STAFF RECOMMENDATION

2615 Barton Avenue

April 16, 2014

Application: New construction – addition, outbuilding; Setback determination

first floor plan
scale: 1/8"=1'0"

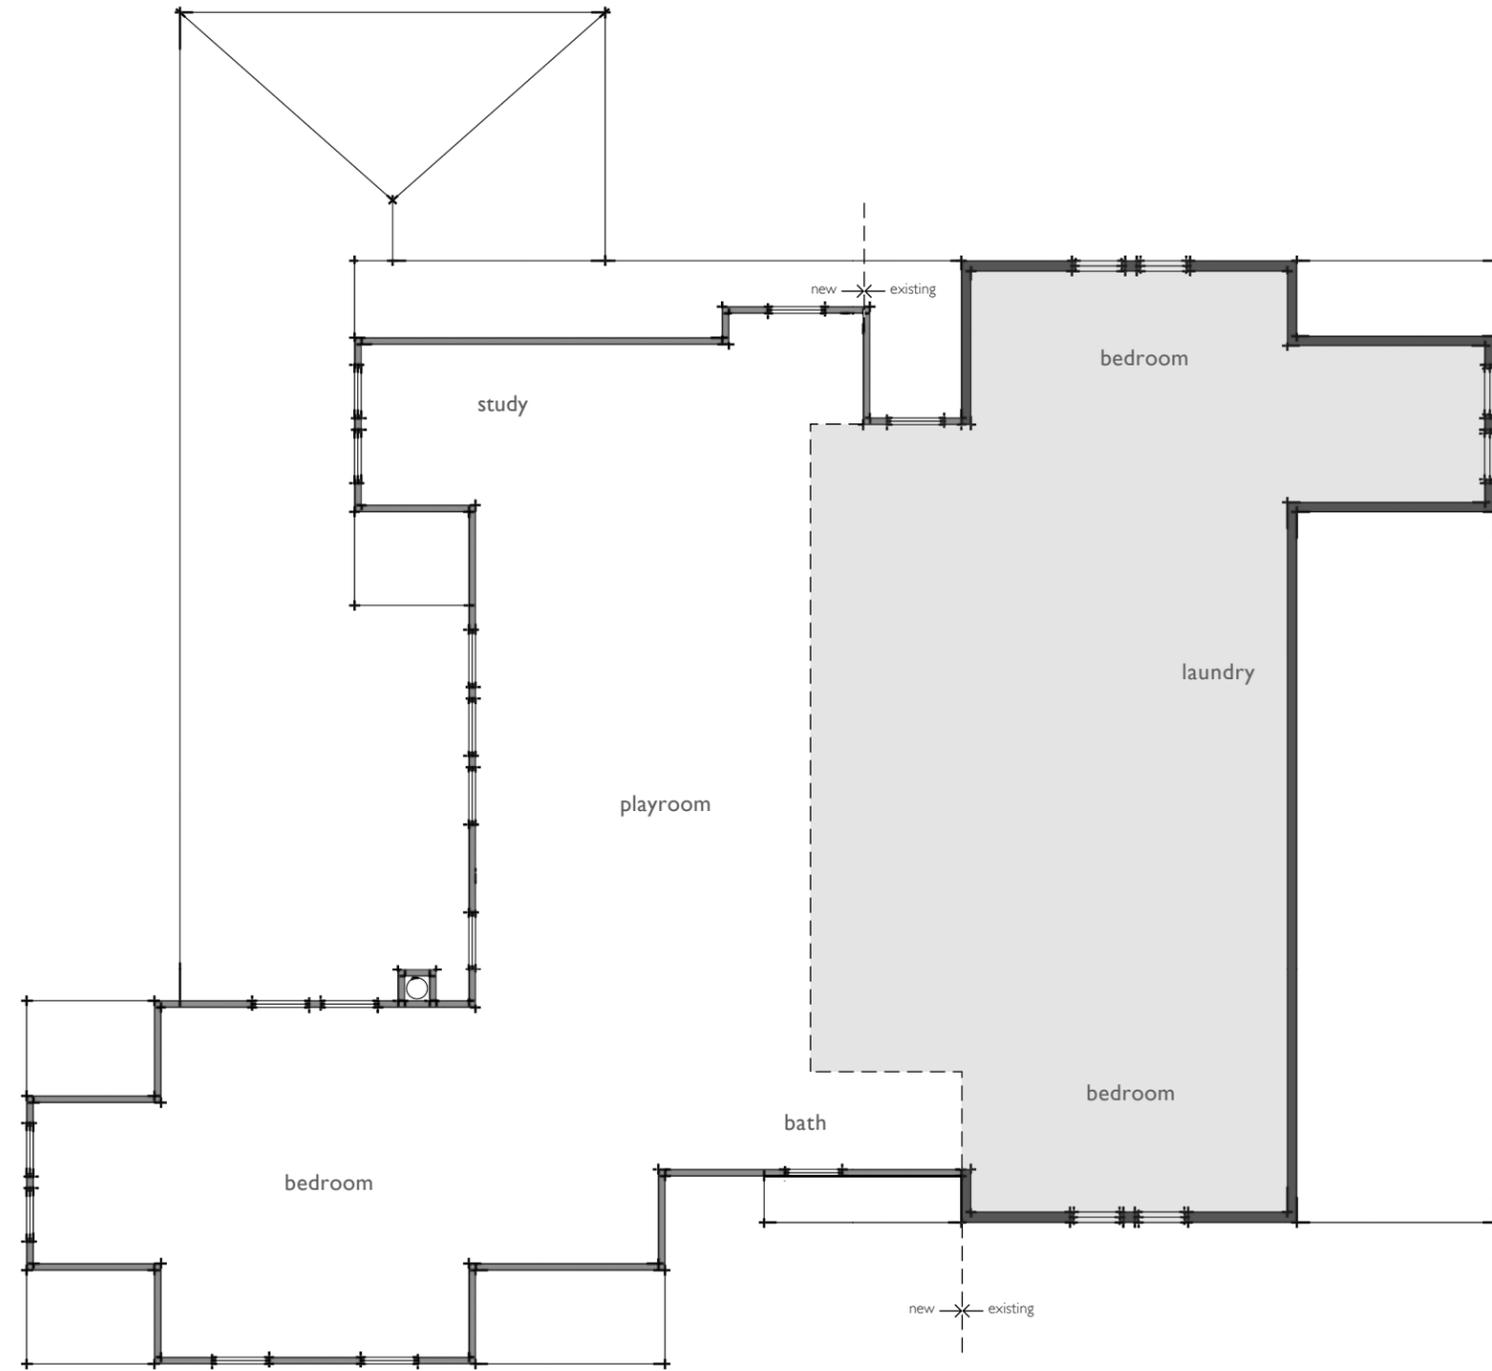
The new rear addition will be set within the “shadow line” of the existing house at the rear before then projecting wider than the house on both sides. The Commission has generally found that it is not appropriate for an addition to be wider than a house on both sides.

On the left side of the house on the first story, the addition will sit in from the rear corner of the house with an “alcove” two feet (2') wide by four feet, five inches (4'-5") deep before then setting out six feet (6') past the outside edge of the house. The addition will not encroach on the standard five foot (5') side setback requirement. The roof of the left

side addition will be eighteen inches (18") lower than the existing roof, with matching floor and eave heights. Staff finds that the addition to the left side would be appropriate because of the width of the lot, because it is sufficiently distinguished from the historic house by the inset and alcove, and because the height and massing is compatible with the historic house.

On the right side the addition will not set in from the existing house, but the new construction will be differentiated from the original by a change in materials which meets the design guidelines. Typically an inset is required except when the addition is minimal as this one is, being only twenty-feet (20') deep, and when there is a change in material. At the rear portion of the addition there will be a porte cochere extending twelve feet, four inches (12'-4") out to the right. The porte cochere would encroach two feet (2') into the standard side setback. Although the Commission can determine setbacks less than are less the standards that the bulk zoning would require, the policy to date has been that it is generally not appropriate for an addition to be wider than a historic house on both sides without a compelling condition (such as where the house is shifted to one side of the lot or the lot is unusually narrow). In addition, the proposal does not meet the Commission's policy for setback determinations as the existing building isn't already encroaching into the setback area and the lot does not have unusual constraints such as shape, size or grade that would necessitate and encroachment into the setback area.

Staff finds that the addition of the porte cochere with a three foot (3') side setback is not appropriate. Without the porte cochere the addition would not be wider than the existing house on the right side and would be compatible with the historic house. With a condition that the porte cochere be eliminated, Staff finds that the addition meets sections II.B.1.a and II.B.1.b of the Hillsboro-West End design guidelines.

- The original front chimney is retained; and
- The existing window openings are not resized; and
- The porte cochere is eliminated; and
- The selection of windows and doors are approved by Staff prior to purchase/installation.

front elevation
 scale: 1/8"=1'0"

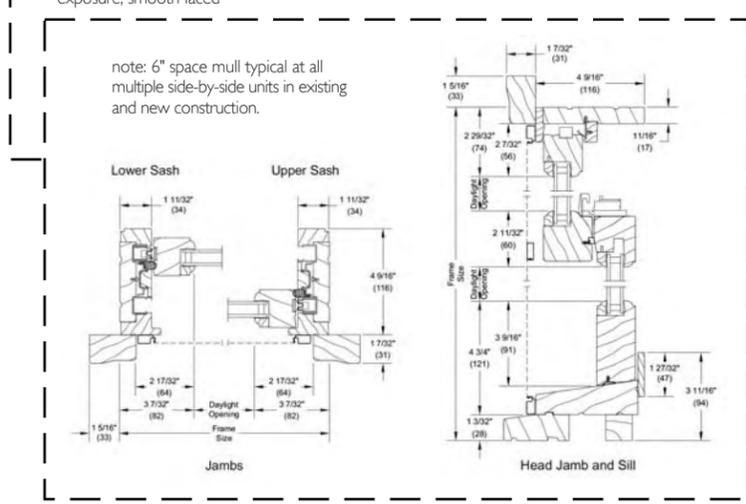
The existing uncovered front stair and landing will be widened from six feet (6') to twenty-two feet (22'). Although the existing stoop is original to the structure and enlarging it would not normally meet guidelines II.B.1.a and II.B.1.b, it is not large enough to be safely used today. When enlarged, the stoop will match the character and materials of the existing stoop, and because it is primarily horizontal in nature it will not significantly alter the look of the original entrance. It does not require the removal or the covering of any significant historic features. For these reasons, Staff finds that enlarging the front stoop would be appropriate under guidelines II.B.1.a and II.B.1.b.

The roofs of the addition will match the roofs of the existing house: gabled with 12:12 and 28:12 pitches. There will be two chimneys on the addition, set behind the ridge of the existing house. These chimneys are appropriate, but removing the existing chimney on the front slope of the roof is not. With a condition that the front chimney remains, Staff finds that these roofs are compatible with the existing structure and meet guideline II.B.1.e.

garage first floor plan
 scale: 1/8"=1'0"
 730 sq. ft.

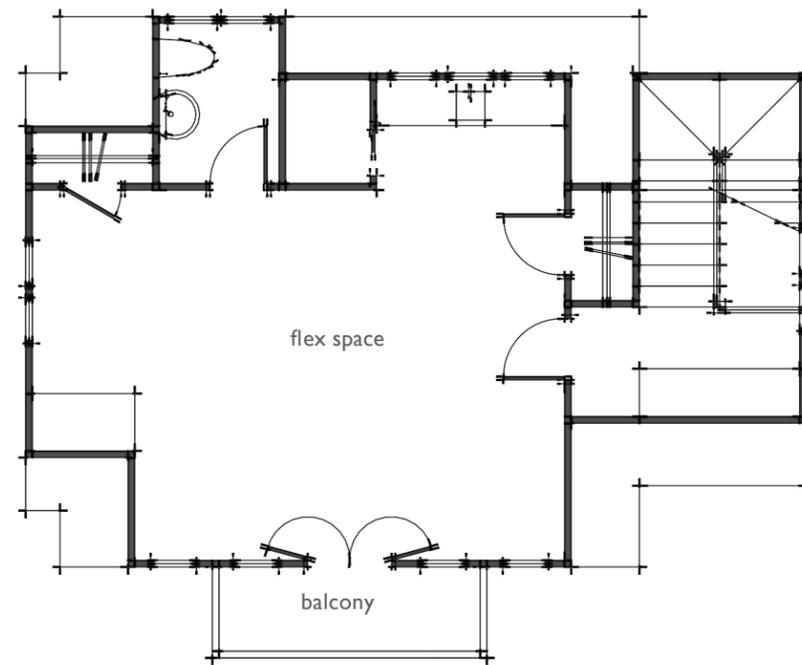
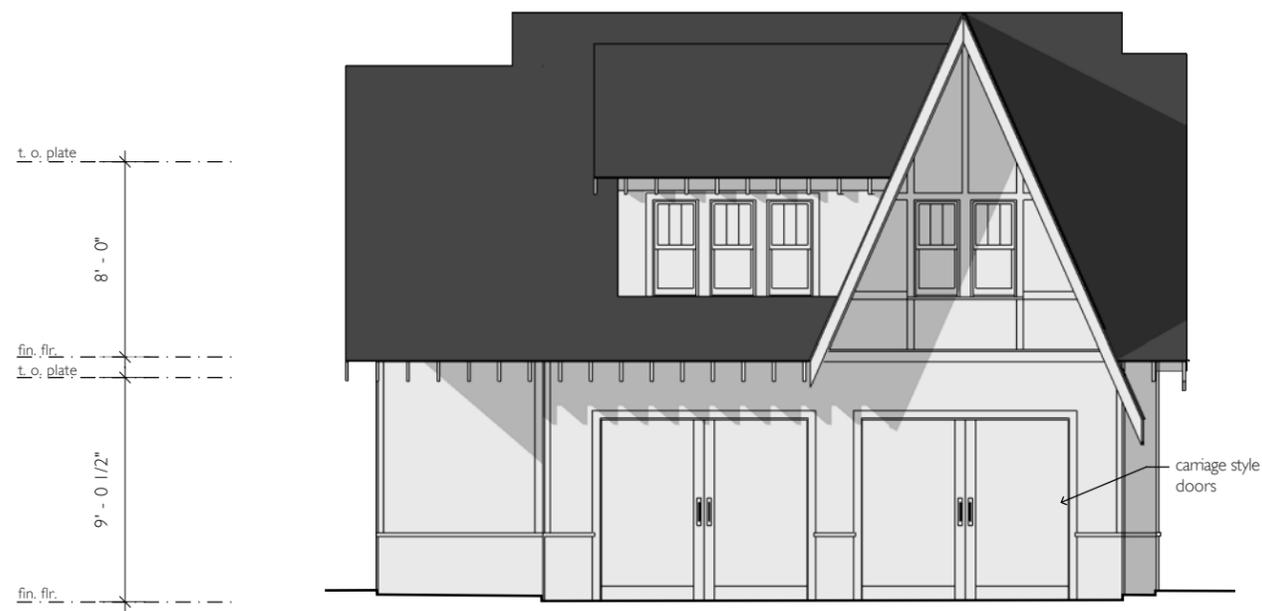
The outbuilding will be one and one-half stories tall with a seven hundred, thirty square foot (730 s.f.) garage area on the first story with a five hundred square foot (500 s.f.) "bonus area" above. The height of the roof will be twenty-six feet (26') above grade, with eaves at ten feet (10'). The historic house, by comparison, is thirty feet (30') tall with eaves at approximately twelve feet (12') from grade. The building will be located behind the house, ten feet (10') from the rear of the property, twelve feet (12') from the left side of the property, and nearly thirty feet (30') from the right. The standard setback requirement for an outbuilding of this size would be twenty feet (20'); however, Staff finds the proposed location to be appropriate as it is compatible with the locations of historic outbuildings. The character of the outbuilding will match the proposed addition: matching roof pitch and form, matching window rhythm and size, and matching exterior finishes. Staff finds that the outbuilding will be compatible with the house and that it meets section II.B.1.h of the design guidelines.
